RANCHO SANTIAGO COMMUNITY COLLEGE DISTRICT

ADDENDUM NO. 1

Bid #1413 BR Signage and Wayfinding
at
Santiago Canyon College

January 18, 2022

DRAWING TITLE:
SIGN DETAILS

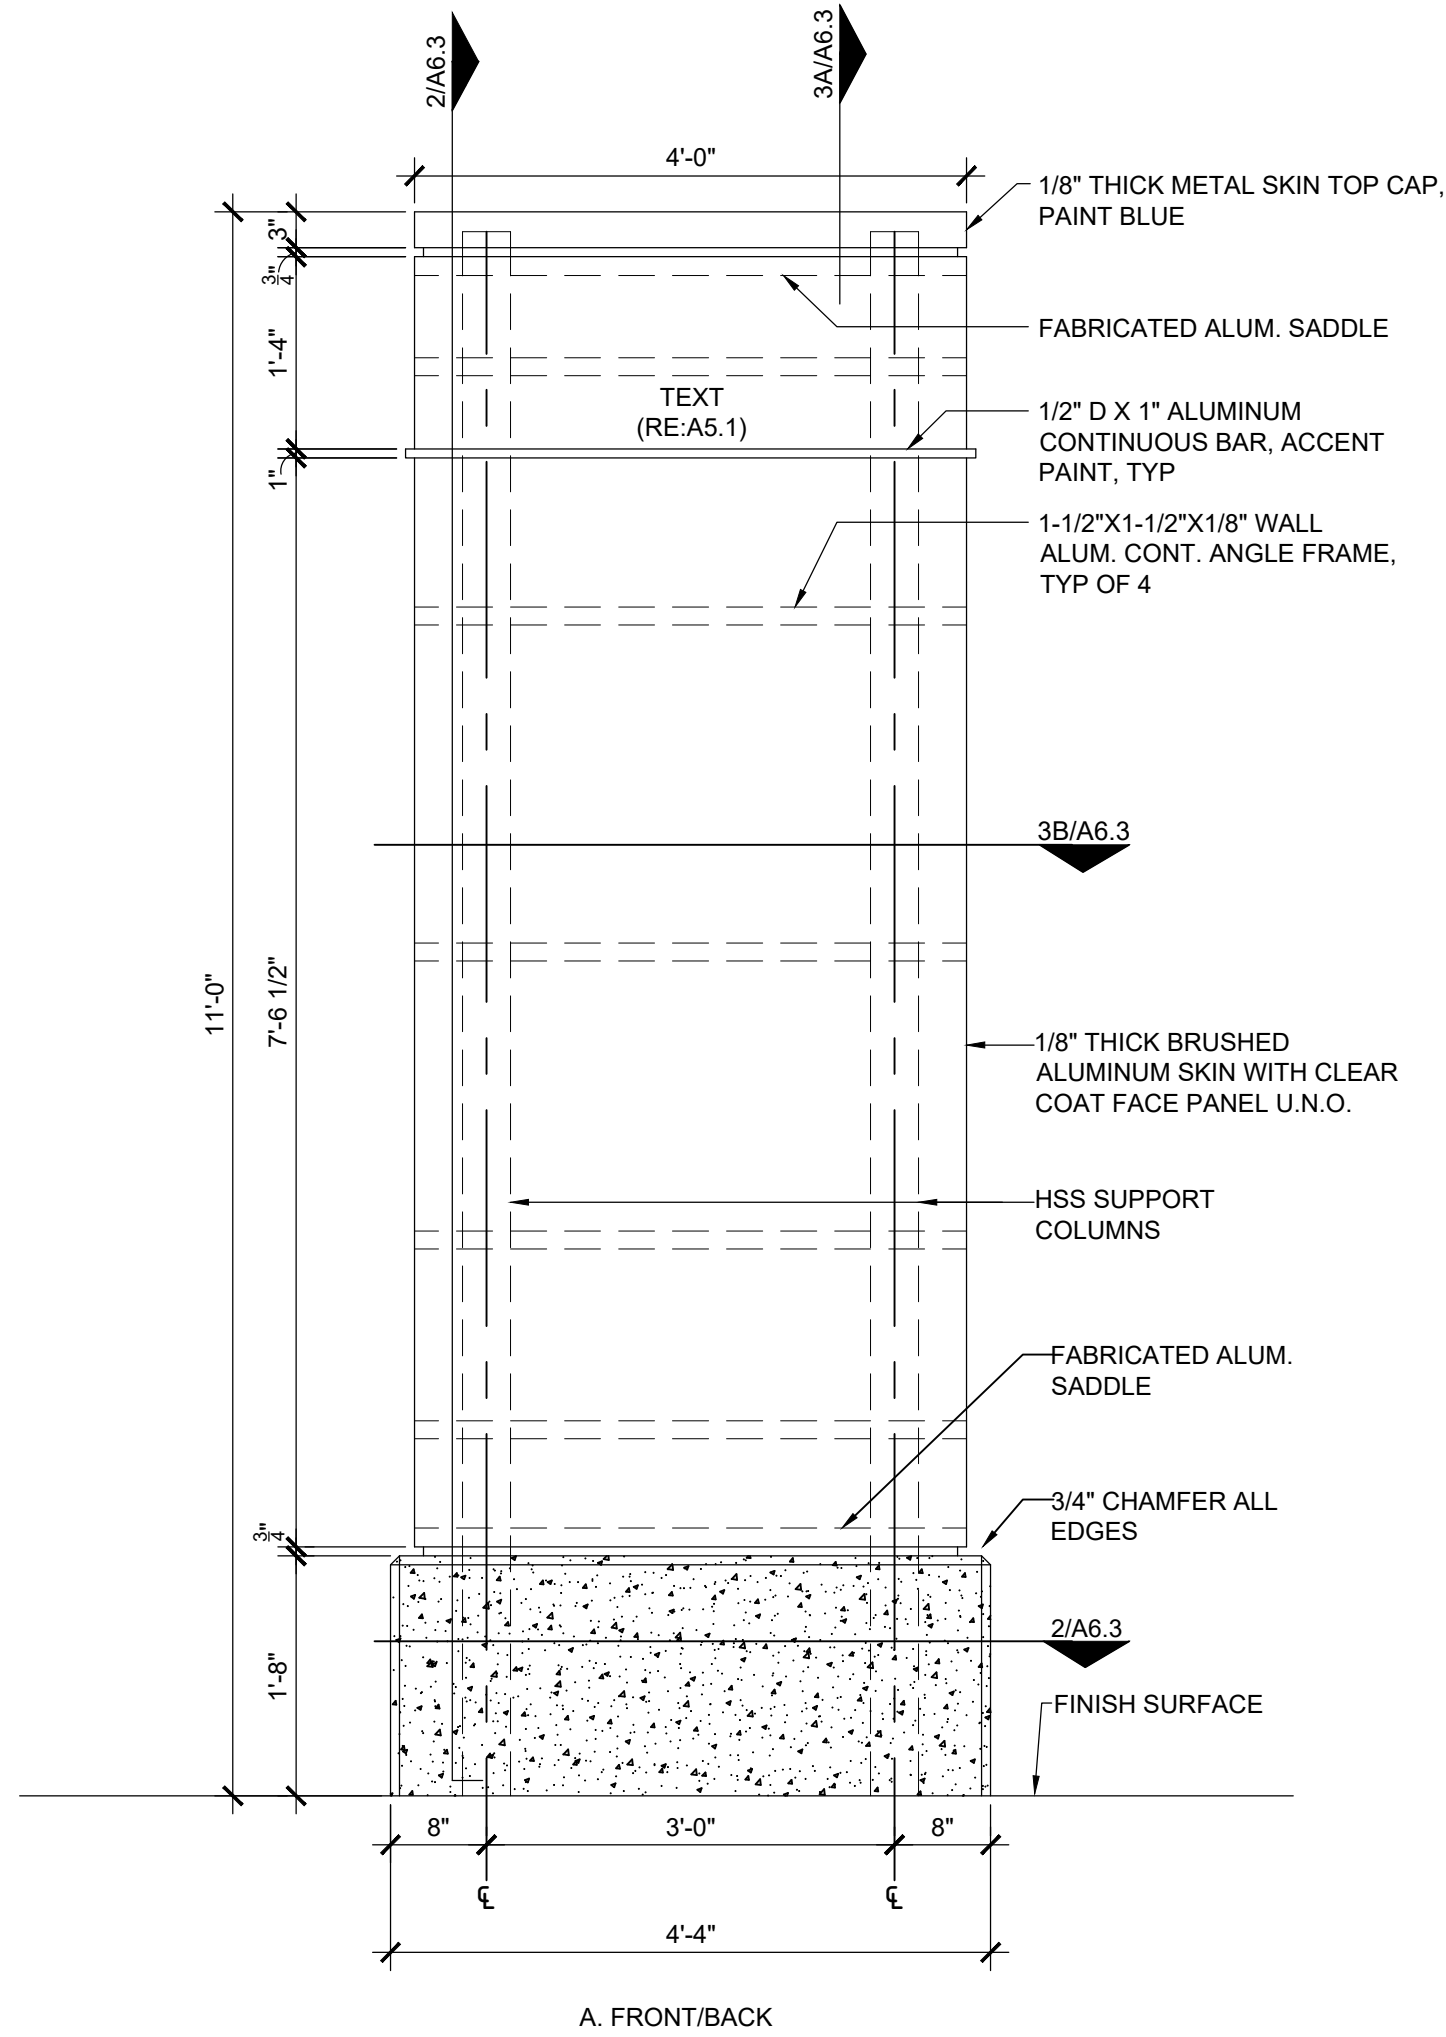
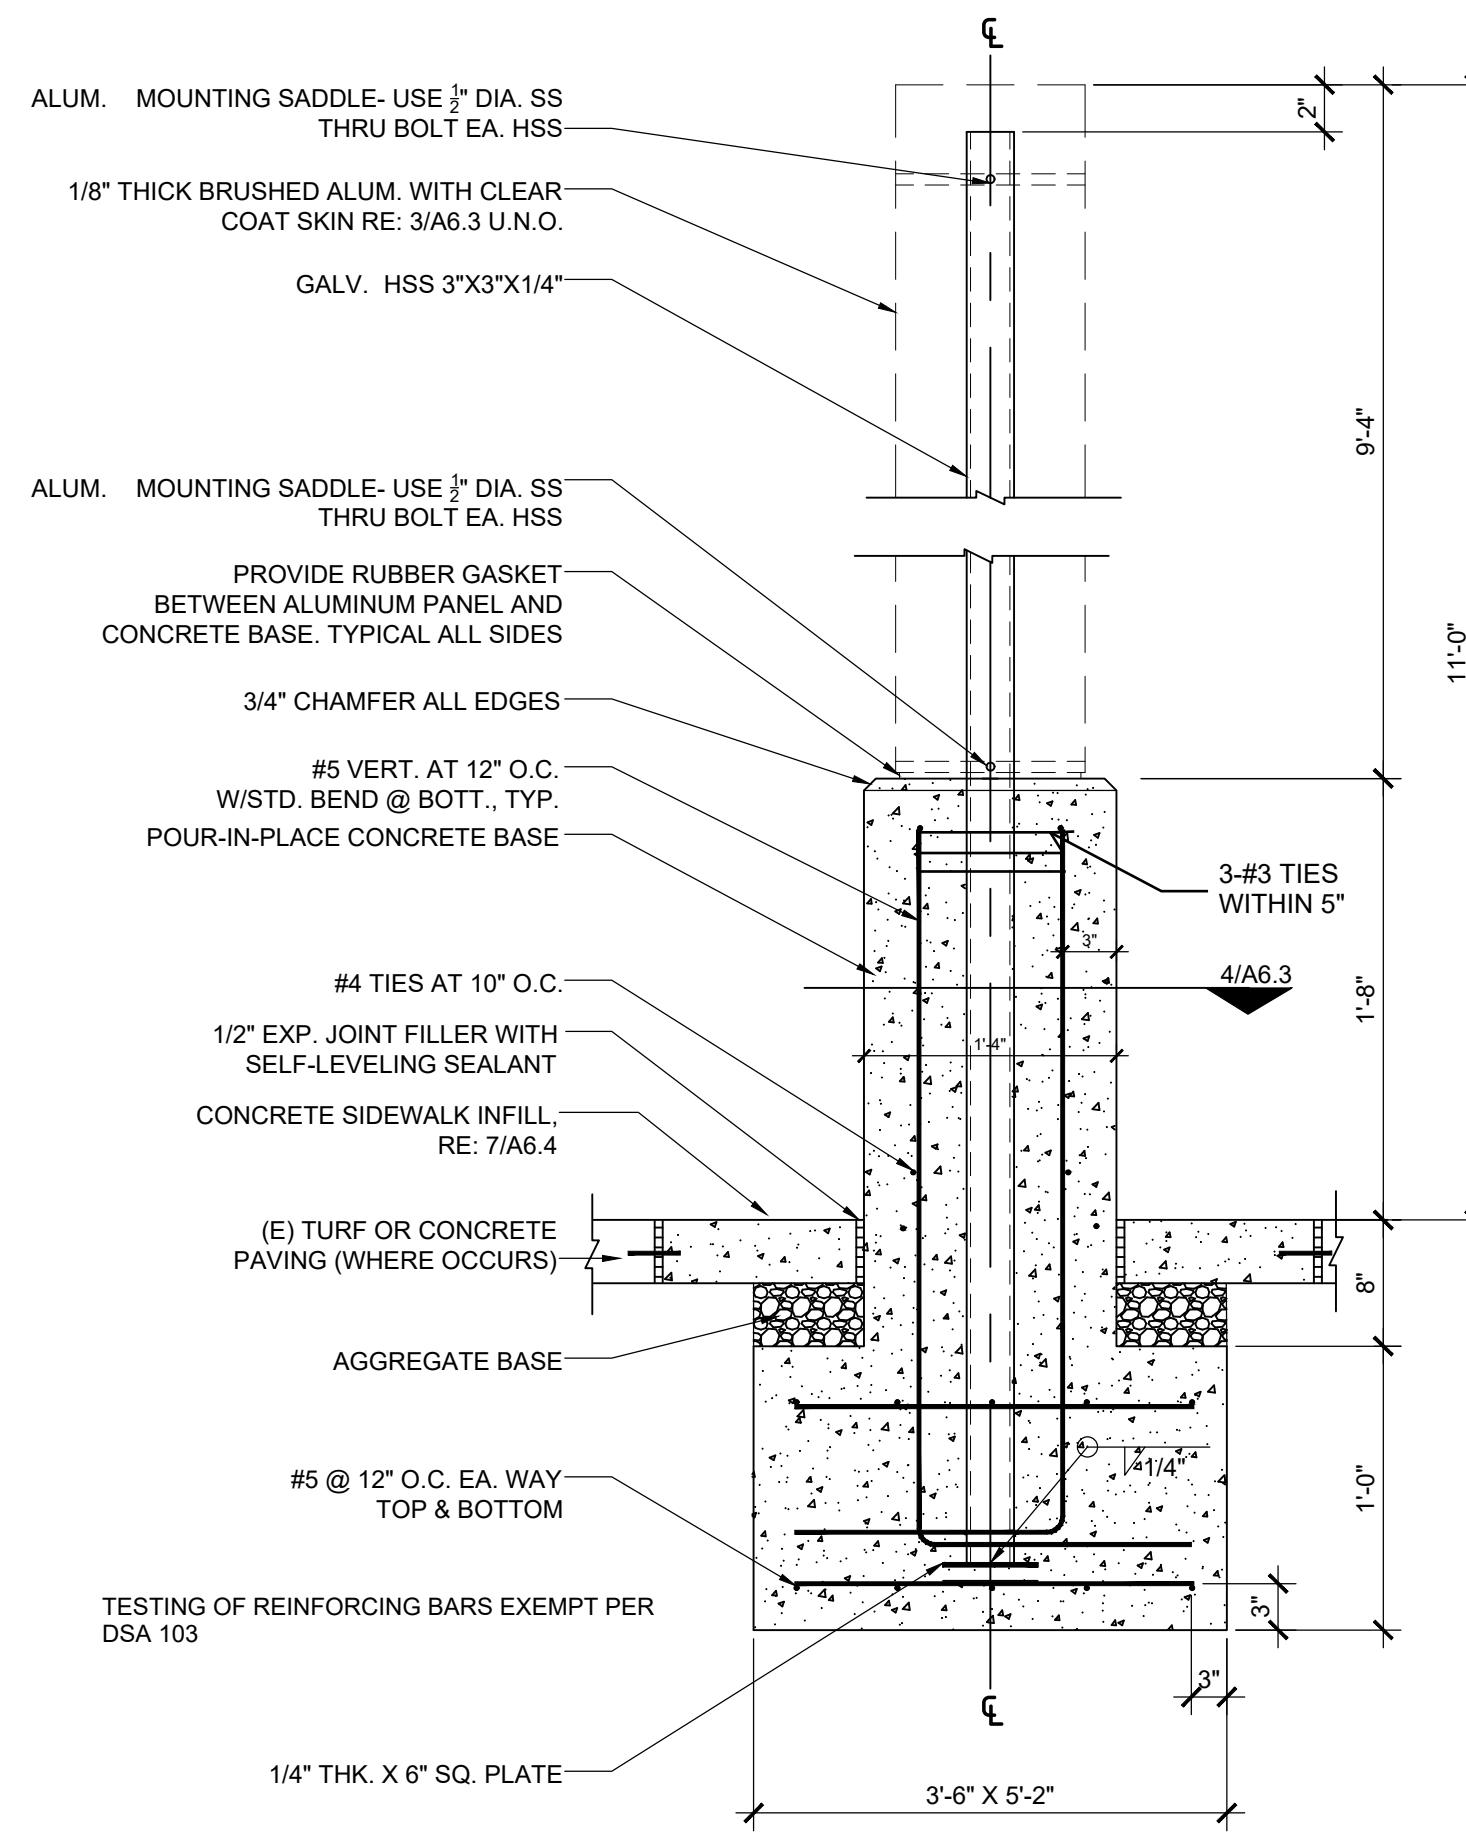
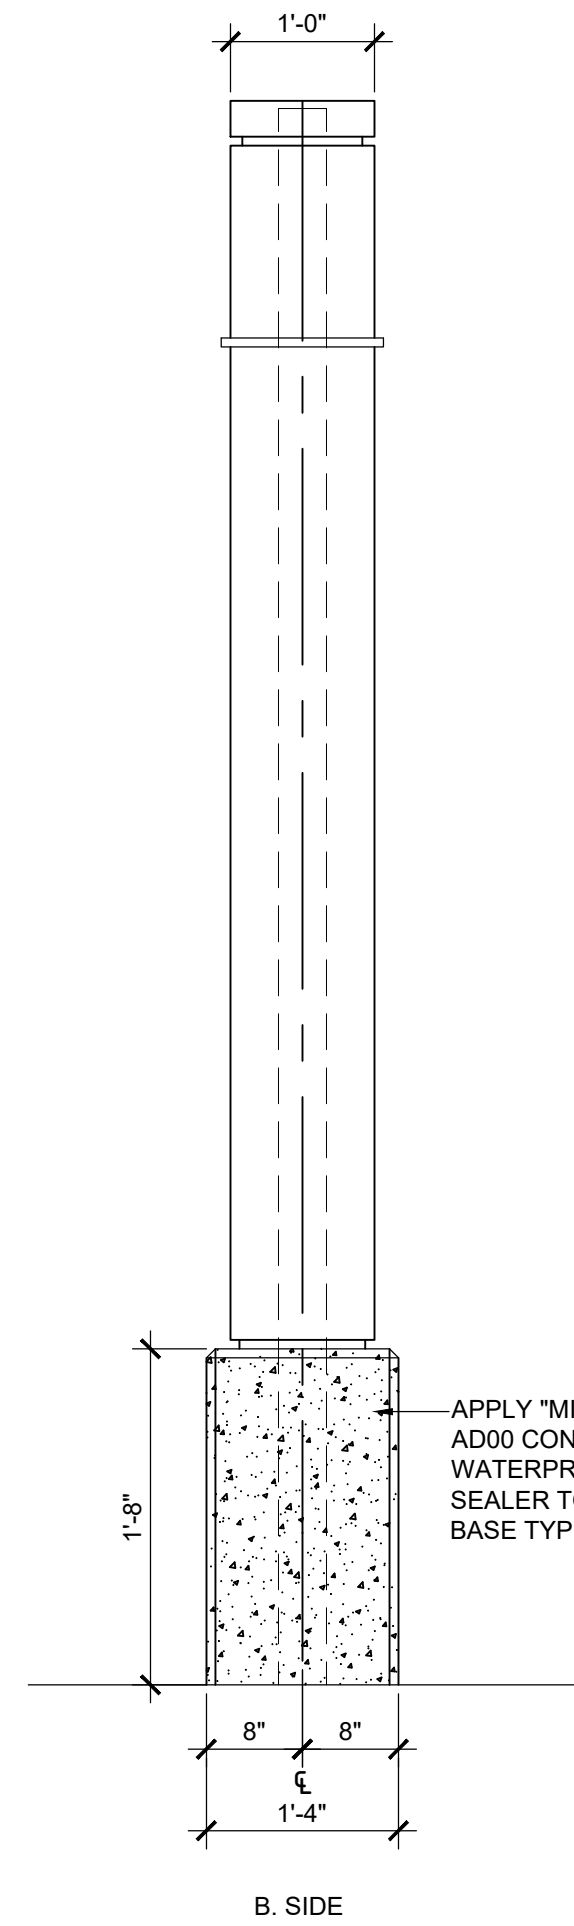
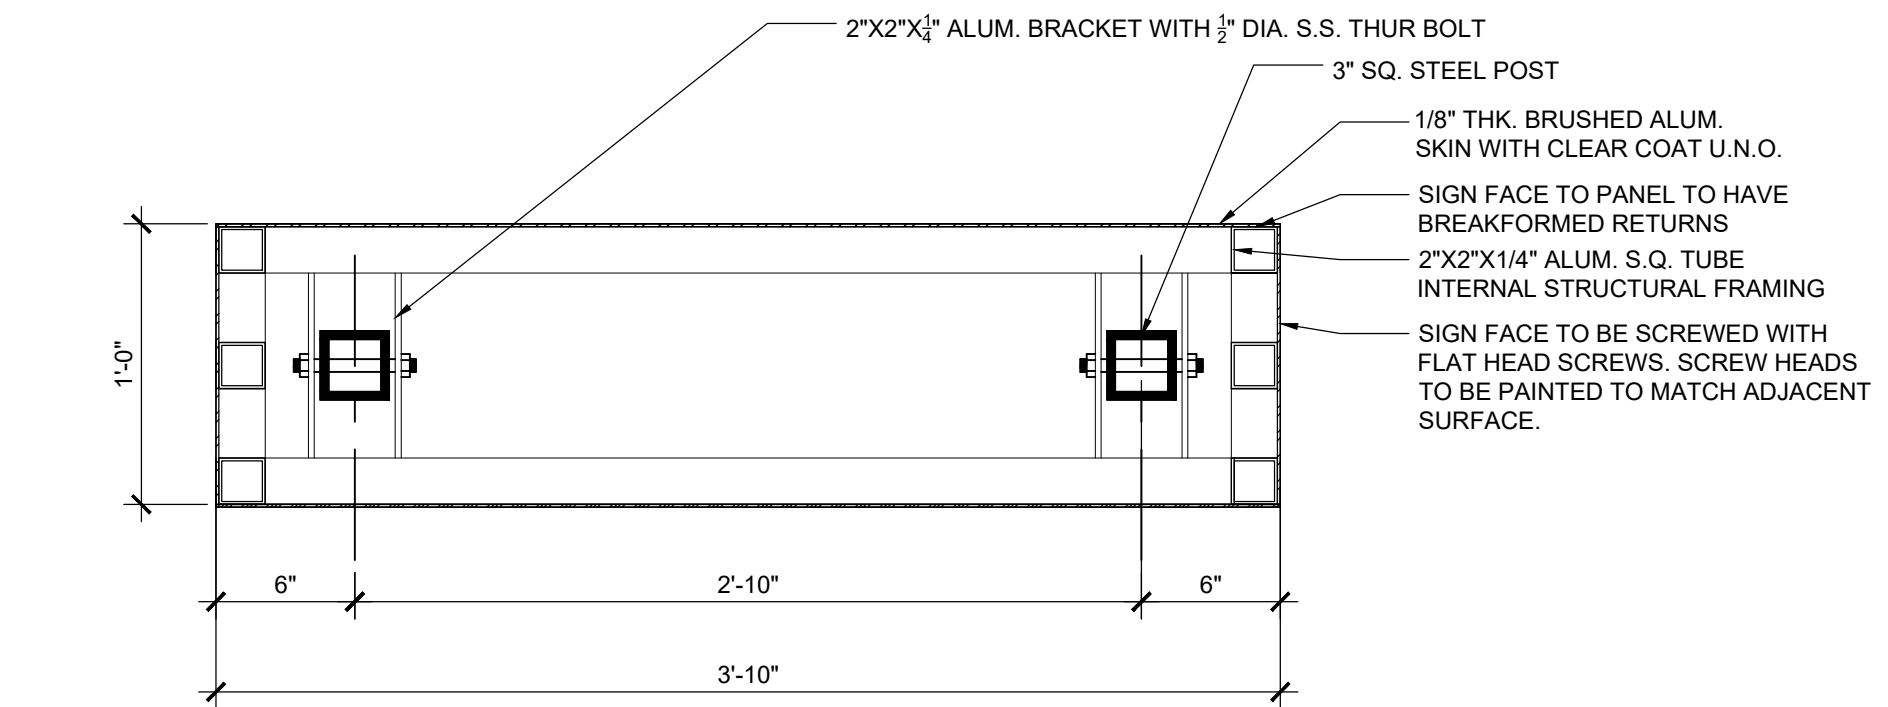
Refer to attached Drawing A6.3, Sign Details, General Notes. Revise General Note No. 1 as follows:

1. Contractor to repair existing hardscape, landscaping and irrigation at new construction, field verify.
 - A. PVC pipe and fittings to match existing.
 - B. Reroute with 45-degree elbows in lieu of 90-degree elbows.
 - C. Adjust adjacent existing sprinkler head positioning where spray is not spraying monuments.
 - D. Sprinkler heads to match existing and approved by District representative.
